**Wichita-Sedgwick County Metropolitan Area Planning Department**

Re: BZA2000-00037 – Amendment to Administrative Permit issued October 18, 2000 for a 150-foot high wireless communication facility on property zoned “LI” Limited Industrial. Generally located north of Kellogg and west of Maize (11118 W. Kellogg).

BZA 2000-00037  
**SITE PLAN**

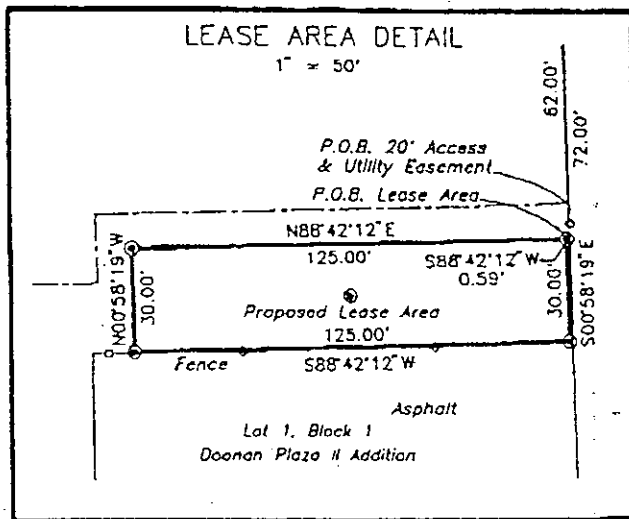
The Compatibility Height Standards require the proposed 150-high wireless communication to be located no closer than 150 feet from the lot line of property zoned “TF-3” Two-Family Residential or more restrictive. The proposed 150-high monopole is shown on the site plan submitted with this application to be located 242.5’ from the nearest lot line of property zoned “TF-3” or more restrictive. Therefore, we find that your request conforms to the Compatibility Height Standards.

4. **The site shall be screened with a 8-foot high solid screening fence on the north, east, and west sides of the compound, with a chain link fence enclosing the south side of the compound.**
